Proposal of Tone Frequency

Tone Frequency of 49 MHz ?

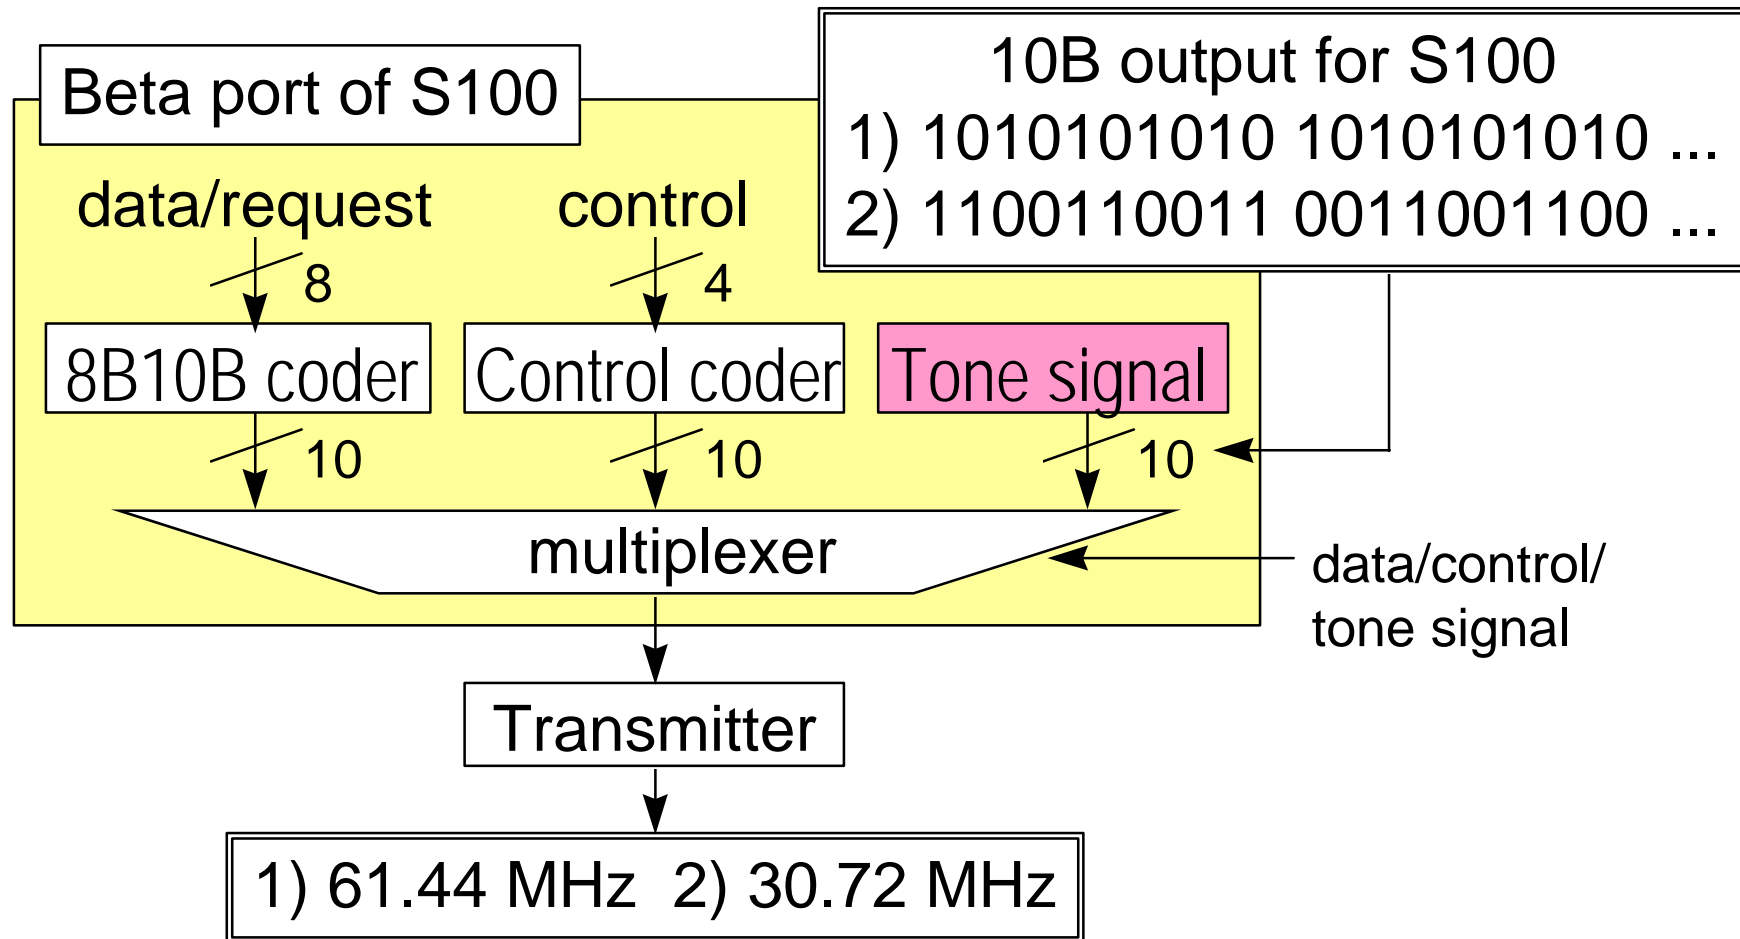
Question: Is this frequency a best solution for beta port of all speed ?

- Beta port of S100 & S200 becomes complex for generating 49MHz tone frequency.

(Additional circuits are needed.)

Other frequencies are better.

- 1) If we choose a single frequency,
we should specify 61.44MHz or 30.72MHz.
(30.72MHz is better for EMI ?)
- 2) If we define a range of frequency,
we should specify a frequency range of
10MHz - 61.44MHz
(within a transceiver bandwidth)
